# Access Compliance Report

## Public Rights-of-Way

### (Curb Ramps)

Intersection ID: 43015	Main Street: BRISTOL_PLACE_CT	Cross Street: SPRINGS_FARM_LN	Location: NW
ADA ID: 7D6981D413B7	Ramp Type: PerpDiag	Initial Pass/Fail: Fail	Overall Compliance: No Severity Score: 13.75

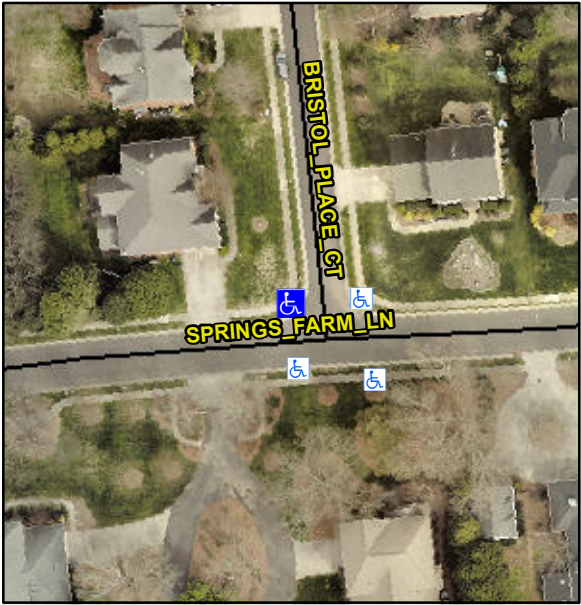
Codes/Mitigation Info/Possible Solution			Field Measurements/Component Compliance		
	Possible Solutions:		<b>Compliance</b>	<b>Description</b>	<b>Data</b>
	<b>Remove &amp; Replace Curb Ramp With Two New Directional Ramps or Equivalent.</b>		<b>No</b>	Ramp Length (in)	<b>48.0</b>
			<b>Yes</b>	Ramp Width (in)	<b>48.0</b>
			<b>N/A</b>	Flare Type LT	<b>N/A</b>
			<b>N/A</b>	Flare Slope LT (%)	<b>N/A</b>
			<b>N/A</b>	Flare Traversable LT?	<b>N/A</b>
			<b>N/A</b>	Landing Length (in)	<b>N/A</b>
			<b>N/A</b>	Landing Width (in)	<b>N/A</b>
			<b>N/A</b>	Landing Slope (%)	<b>N/A</b>
			<b>N/A</b>	Landing X Slope (%)	<b>N/A</b>
<p>Surveyor Notes:</p> <p><b>N/A</b></p> <p>PROW/ADA:</p> <p><b>Not Found, R304.2.2, R304.5.3</b></p>			<b>N/A</b>	Flare Type RT	<b>N/A</b>
			<b>N/A</b>	Flare Slope RT (%)	<b>N/A</b>
			<b>N/A</b>	Flare Traversable RT?	<b>N/A</b>
			<b>N/A</b>	DWS Provided?	<b>N/A</b>
			<b>N/A</b>	DWS Contrast?	<b>N/A</b>

<b>N/A</b>	DWS Length (in)	<b>N/A</b>
			<b>N/A</b>	DWS Full Width?	<b>N/A</b>
			<b>N/A</b>	DWS Offset (in)	<b>N/A</b>
			<b>N/A</b>	Shared Landing?	<b>N/A</b>
			<b>N/A</b>	Gutter Ponding?	<b>N/A</b>
			<b>N/A</b>	Gutter Lip Ht (in)	<b>N/A</b>
			<b>N/A</b>	Painted X Walk1?	<b>No</b>
				X Walk 1 Direction	<b>To S</b>
			<b>N/A</b>	X Walk 1 Width (in)	<b>N/A</b>
				X Walk 1 Slope (%)	<b>2.8</b>
				X Walk 1 X Slope (%)	<b>1.4</b>
			<b>N/A</b>	Ramp inside XWalk1?	<b>N/A</b>
				Road Slope (%)	<b>0.3</b>
				Road X Slope (%)	<b>5.0</b>
			<b>N/A</b>	Any Obstructions?	<b>N/A</b>
				Obstruction Type	
Total Cost: \$ 3200.00			<b>N/A</b>		<b>N/A</b>
			<b>Yes</b>	Surface Condition? (G/P)	<b>Good</b>
